Re: **Rosillo Ranch, TIF**

MDP/UD # 873

The Development Review Committee has reviewed **Rosillo Ranch** Master Development Plan **M.D.P./UD # 873** and the associated Land Use Plan. Please find enclosed a signed copy for your files. However, please note the following conditions:

MASTER DEVELOPMENT PLAN NO. 873

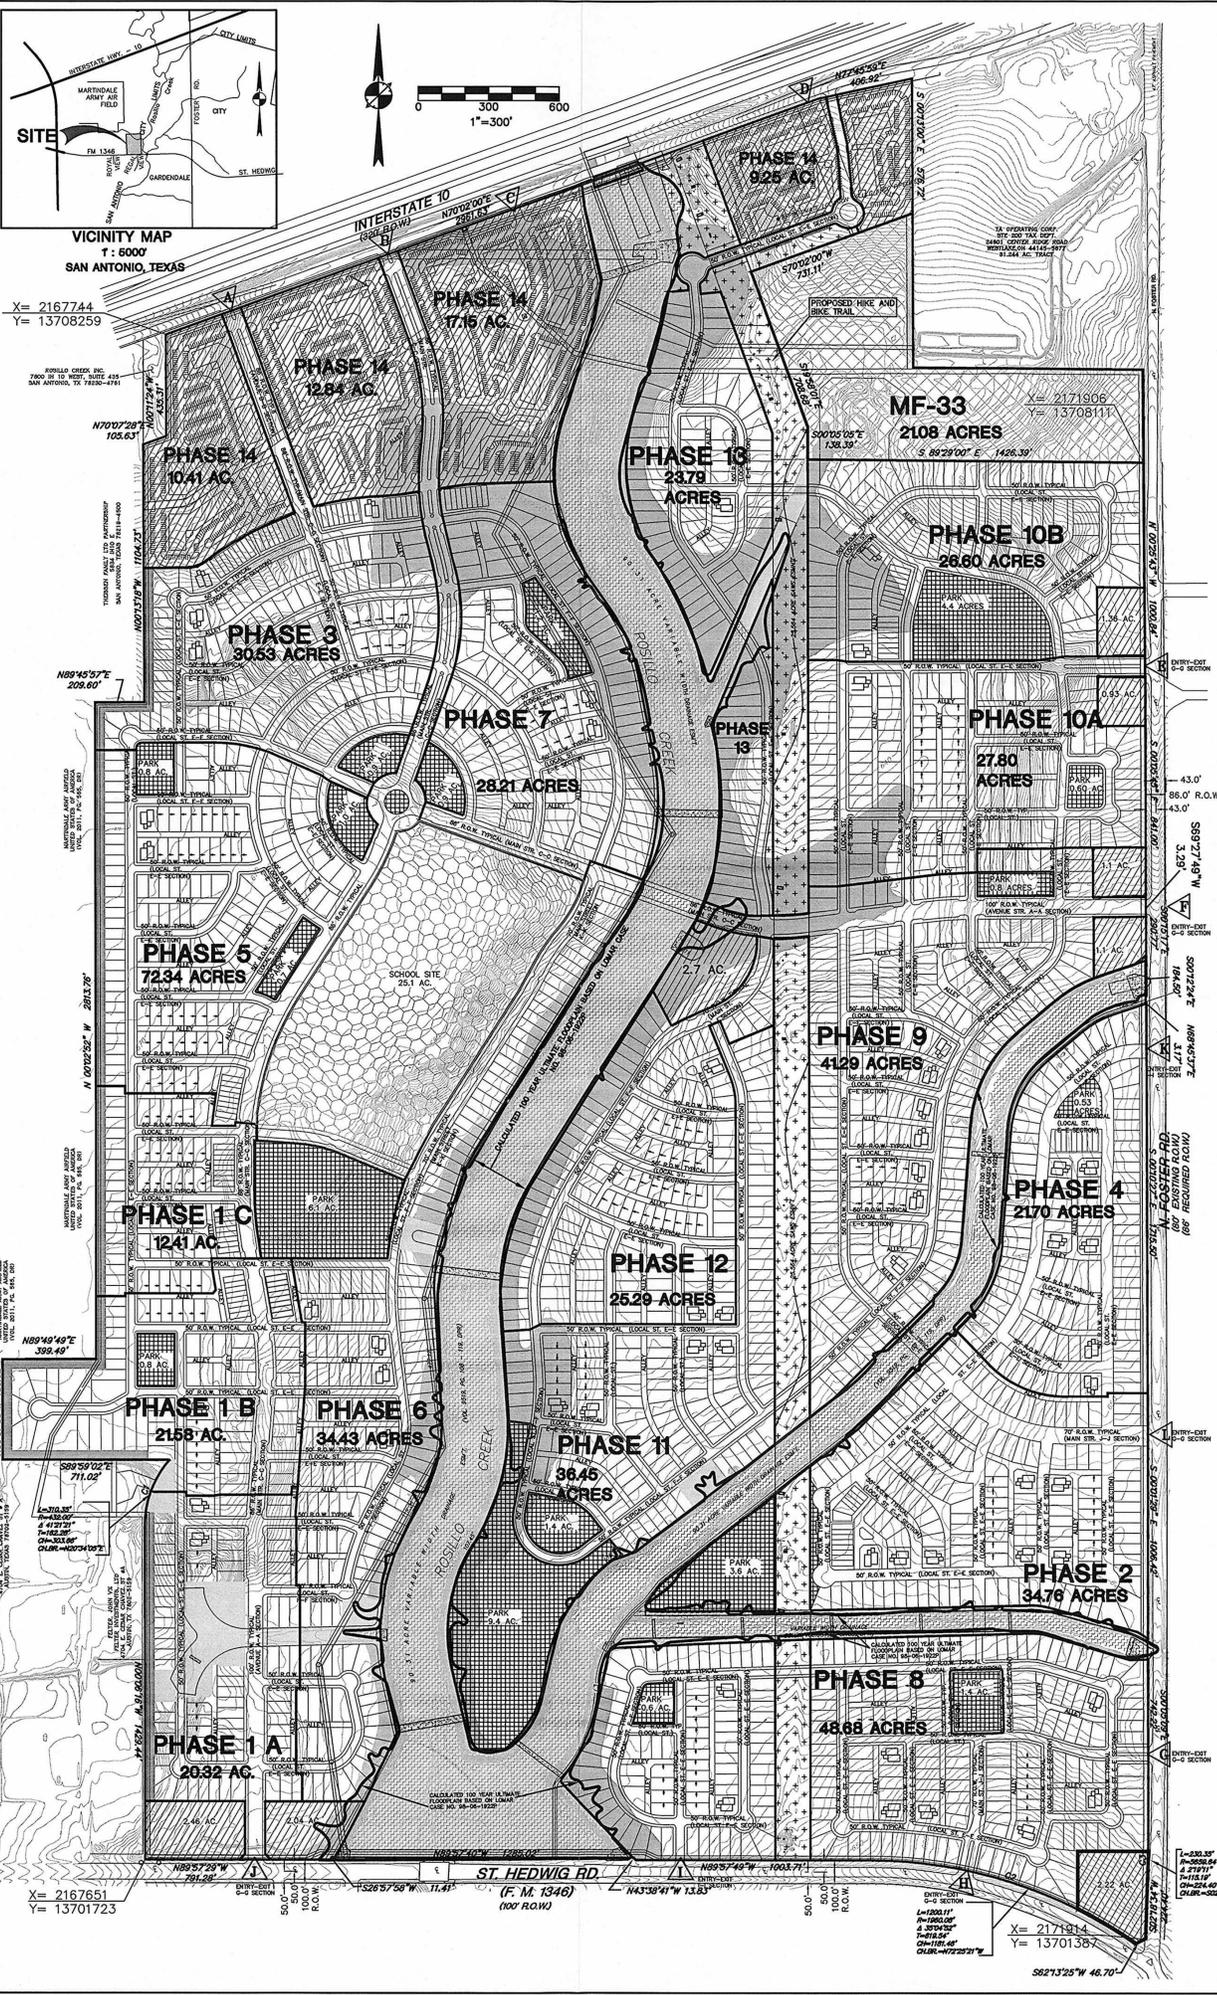
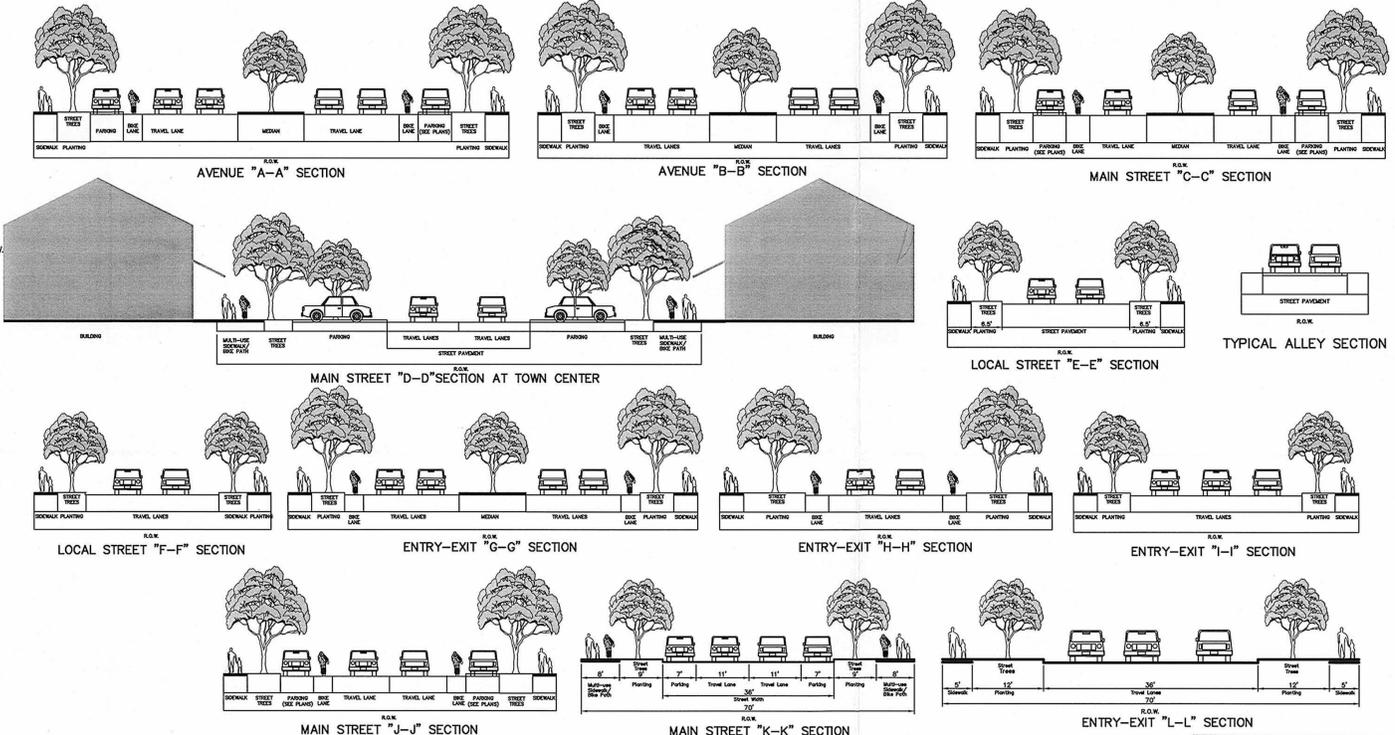
In consideration of public safety and convenience, excessive grades by reason of topography should be avoided in street layouts and arrangements. Any access and R.O.W. issues along state facilities will need to be resolved with the **Texas Department of Transportation (TXDOT)**. For information about these requirements you can contact TXDOT at 615-5814.

The Texas Sites Atlas indicates that archaeological sites 41BX770, 41BX772, 41BX782, and 41BX784 have been previously identified within/nearby the above referenced property. Also, the property may contain other sites, some of which may be significant. The property may contain historical architectural sites that have been recommended for further investigation. Thus, before any work that might affect any sites is begun we recommend that a qualified professional conduct an archaeological investigation of the property. The investigation should be performed according to Archeological Survey Standards for Texas, and previously identified sites should be reexamined and reevaluated, if any. A list of qualified archaeological consulting firms is available on line at www.c-tx-arch.org. The consultant may need to obtain an antiquities permit from the SHPO prior to starting the investigation. A report of findings should be prepared according to the Council of Texas Archeologists [CTA] Guidelines for Cultural Resource Management Reports and submitted to the HPO and SHPO for review. Copies of the survey standards and the CTA guidelines may be obtained by calling the SHPO at 512-463-6096 or writing to P.O. Box 12276, Austin, Texas 78711-2276. Law allows both the HPO and SHPO 30 days from receipt for reviews.

The Rosillo Ranch Master Development Plan/Urban Development Plan (UD) and associated Land Use Plan, is subject to the UD standards of the Unified Development Code. The block lengths shown on the plan are in compliance of the UD 35-310.15(b) requirements. However, traffic calming measures will be assessed and implemented at platting as per the Unified Development Code Section 35-506(t). Furthermore, any variance to Section 35-310.15 of the Urban Development (UD) provisions will need to be processed through the Board of Adjustment. The UD provisions will be reviewed at every stage of the development process.

All platting shall comply with the Unified Development Code (UDC), Master Plan, Major Thoroughfare Plan, and all applicable regulations for the City of San Antonio. It will be expected that all of the property depicted in your Master Development Plan to include floodplains, drainage areas, and open space shall be platted. It is also suggested to work closely with the school district, so they can plan accordingly.
